Access Compliance Report

Public Rights-of-Way

Intersection ID: 14553	Main Street: MONROE_RD	Cross Street: BRIAR_CREEK_RD	Location: SE
ADA ID: C4AC35708A6F	Ramp Type: Perp	Initial Pass/Fail: Fail	Overall Compliance: No
Severity Score: 12.5			
Codes/Mitigation Info/Possible Solution		Field Measurements/Component Compliance

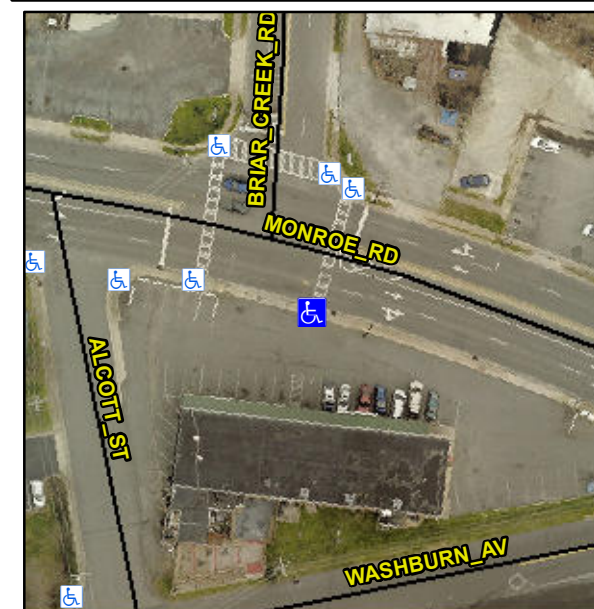
Not Found, R304.2.2

Compliance	Description	Data	Compliance	Description	Data
N/A	Ramp Length (in)	61.0	No	Ramp Slope (%)	11.3
Yes	Ramp Width (in)	48.0	Yes	Ramp XSlope (%)	0.6
N/A	Flare Type LT	N/A	N/A	Flare Type RT	N/A
N/A	Flare Slope LT (%)	N/A	N/A	Flare Slope RT (%)	N/A
N/A	Flare Traversable LT?	N/A	N/A	Flare Traversable RT?	N/A
N/A	Landing Length (in)	N/A	N/A	DWS Provided?	N/A
N/A	Landing Width (in)	N/A	N/A	DWS Contrast?	N/A
N/A	Landing Slope (%)	N/A	N/A	DWS Length (in)	N/A
N/A	Landing X Slope (%)	N/A	N/A	DWS Full Width?	N/A
N/A	Landing Curb? (Y/N)	N/A	N/A	DWS Offset (in)	N/A
N/A	Shared Landing?	N/A			
N/A	Gutter Ponding?	N/A	N/A	Gutter Slope (%)	N/A
N/A	Gutter Lip Ht (in)	N/A	N/A	Gutter X Slope (%)	N/A
N/A	Painted X Walk1?	Yes	N/A	Painted X Walk2?	N/A
	X Walk 1 Direction	To NE		X Walk 2 Direction	N/A
N/A	X Walk 1 Width (in)	55.0	N/A	X Walk 2 Width (in)	N/A
	X Walk 1 Slope (%)	1.9		X Walk 2 Slope (%)	N/A
	X Walk 1 X Slope (%)	0.1		X Walk 2 X Slope (%)	N/A

Remove & Replace Entire Ramp.
